Sydney Metro Northwest:

Kellyville Station Precinct Concept State Significant Development Application (SSD 10343)

Response to Submissions Report

Figure 6: Revised Setback Scheme

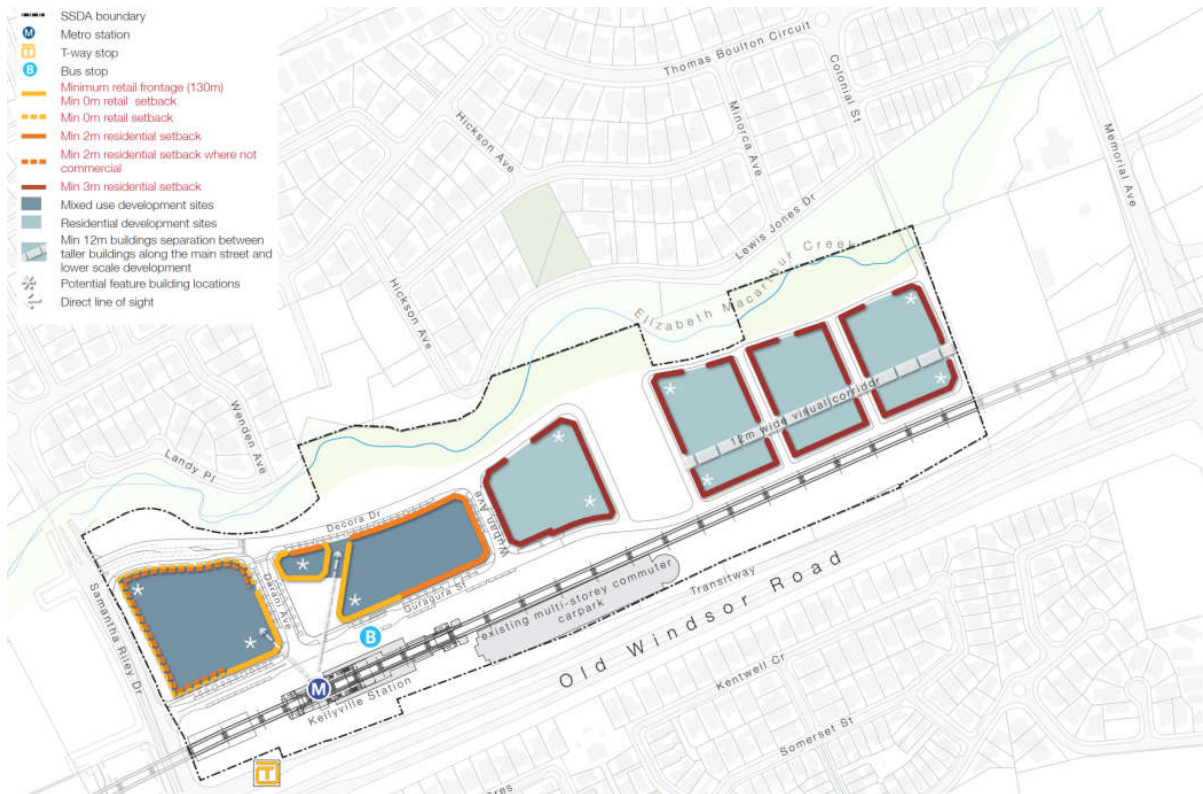
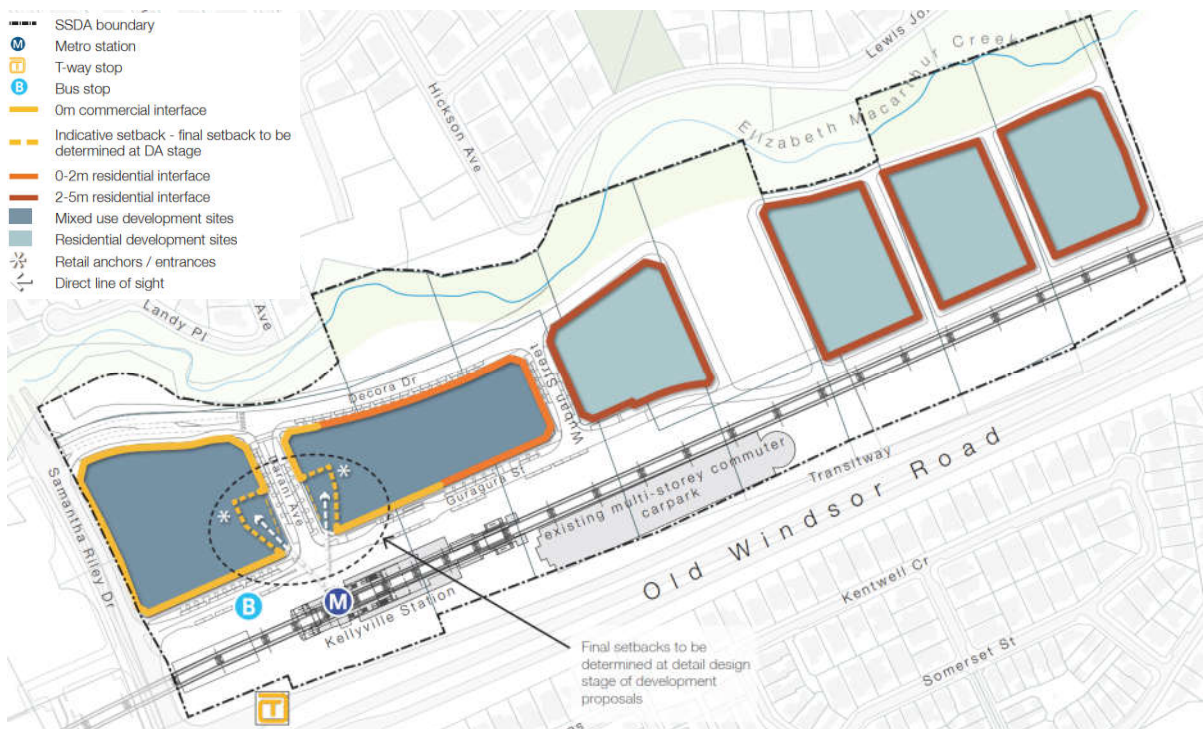
DPIE, THSC, the SDRP and several submissions from the public raised the proposed setback controls and the clause 4.6 variation request provided with the EIS. While Endeavour Energy commented on the reduced setbacks with respect to pad mount substations, it was noted design alternatives can be considered as part of the detailed design for future applications. The clause 4.6 request to vary the setback development standard for Kellyville Station Precinct has been revised to provide further justification for the reduced setbacks and is attached at **Appendix L**.

The proposed setbacks that would apply to future applications have been reviewed and updated in the Urban Design Report at **Appendix A** and Design Guidelines at **Appendix B**. The amended setback scheme is detailed in **Table 6** below and comparative layouts shown in Figure 6 through to Figure 10. The setback scheme sought as part of the EIS is shown in the shaded grey column.

Figure 13: Encroachment into inner and outer VRZ after site footprint adjustment

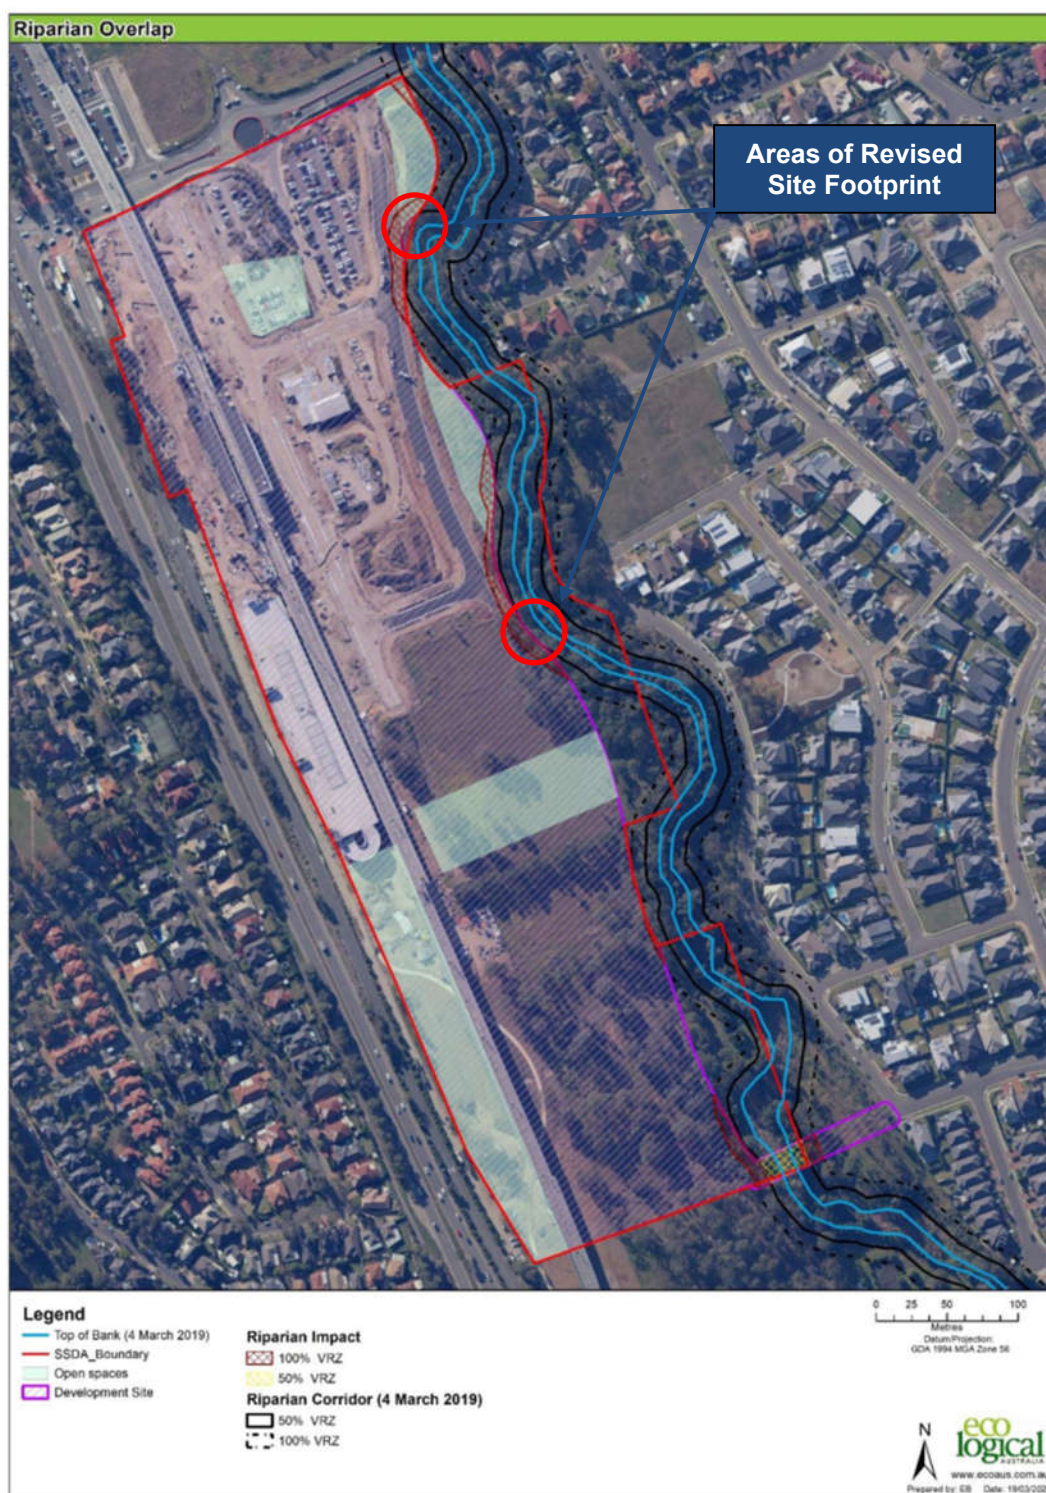
The development footprint of the Kellyville concept SSDA has been adjusted in response to comments from NRAR to ensure impacts on the inner 50% of the vegetated riparian zone (**VRZ**) are mitigated. The updated mapping in the riparian assessment demonstrates the development footprint (purple outline) avoids the 50% VRZ area of Elizabeth Macarthur Creek. As discussed in Section 3 of the report,

this area has been excluded from development footprint, however it should be noted these areas remain within SSDA boundary (red outline). The revised riparian mapping is provided in Figure 13. Full Details of this change are provided in the riparian response cover letter at **Appendix I**.
